**TOWN AND COUNTRY PLANNING ACT 1990 (AS AMENDED)
SECTION 96A (NON-MATERIAL AMENDMENT) APPLICATION TO PLANNING PERMISSION
REF: 2026/90937 (REDEVELOPMENT OF SCHOOL) FOR PROPOSED MINOR AMENDMENTS
TO APPROVED LAYOUT
GOMERSAL ST MARY'S PRIMARY SCHOOL, SHIRLEY AVE, GOMERSAL, BD19 4NA**

On behalf of Bowmer and Kirkland Limited (B+K) for Gomersal St Mary's Primary School and the Department for Education (The DfE), enclosed is an application proposing minor changes to the layout associated with planning permission ref: 2026/90937.

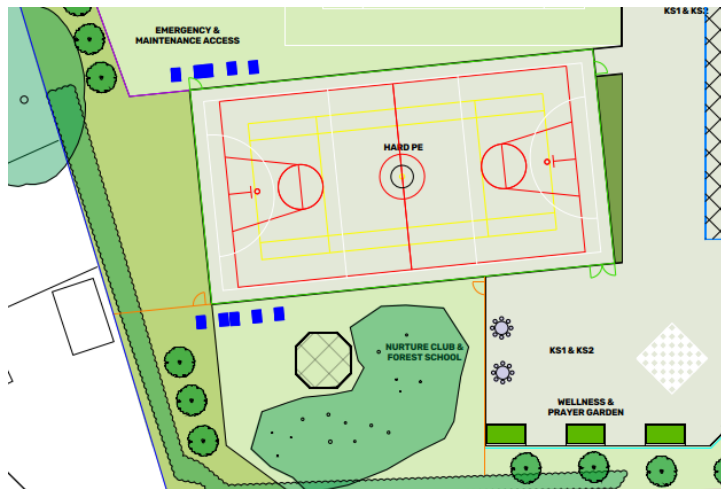
The hard PE area is proposed to be moved approximately 1.5m to the west to allow the drainage inspection chambers to be located outside of the playing area. This will ensure the drainage system can be accessed and maintained without affecting use of the hard PE area. Extracts from the approved and revised whole site plans have been provided below for comparison (the repositioned hard PE area remains within the location of the existing hard PE area).
